UNITED STATES PATENT AND TRADEMARK OFFICE

APPLICATION NO.	FILING DATE	FIRST NAMED INVENTOR	ATTORNEY DOCKET NO.	CONFIRMATION NO.
19/120,393	04/11/2025	Kazuya MOTOHASHI	Q308105	1485

Office Action Summary	Application No. 19/120,393	Applicant(s) MOTOHASHI, Kazuya	
	Examiner MATTHEW J PEERCE	Art Unit 2875	AIA (First Inventor to File) Status Yes

DETAILED ACTION

FIG. 4

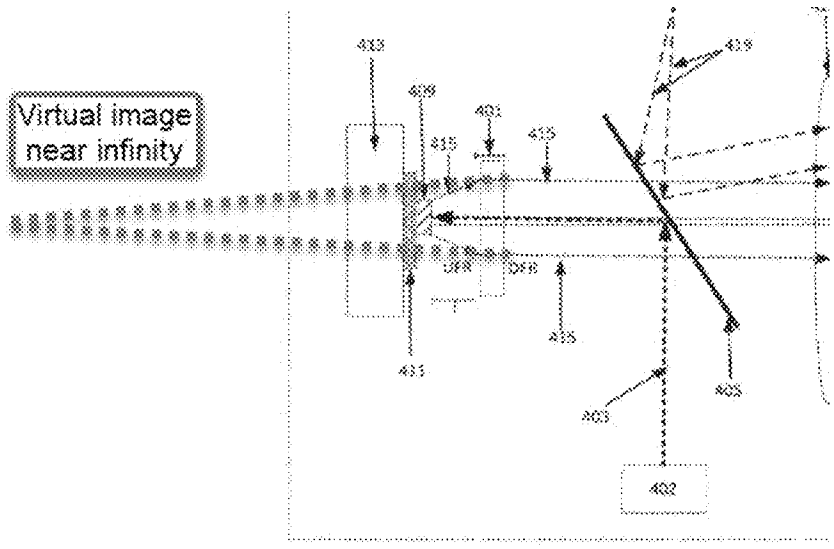
Regarding claim 1, Byrnes teaches a vehicle headlight (see col. 15 lines 15-25, may be used as a headlamp, see fig. 4) comprising:

a light source (light source 402);

a meta-lens (metalens 401) including a meta-region (region with nanostructures) in which a plurality of nanostructures each having a width smaller (see col. 7 lines 24-49, for visible light applications has width less than or equal to 500 nm) than a largest wavelength (largest wavelength is about 700 nanometers, see col. 6 lines 1-12) of light emitted from the light source is arranged and through which the light emitted from the light source is transmitted; and

a projection lens (optics 423, such as projection optics see col. 13 line 64) through which the light emitted from the meta-lens is transmitted, wherein the meta-lens reduces a divergence angle of the light incident on the meta-region from the light source and emits the light (see fig. 4, reduces divergence from 409 and collimates the light; see col. 24 lines 52-55, results in 1.1 degree FWHM, i.e. not fully collimated), and

when the light source is viewed from a side of the projection lens via the meta region, a virtual image of the light source that is emitted through the projection lens via the meta-region is to be located rearward of an actual position of the light source (see fig. 4, meta lens reduces divergence which moves virtual image backwards, near infinite for collimated light, projection lens projects enlarged image).

The Examiner notes that Byrnes teaches that the meta lens emits "collimated light", however Byrnes later notes that the light is not completely collimated, but that it provides a "highly collimated" light, that is still divergent at 1.1 degree FWHM, or that diverges at 27 degrees as noted in col. 26. The claim states "a spreading angle larger than that of collimated light" but does not recite the amount of collimation in the example being compared to.
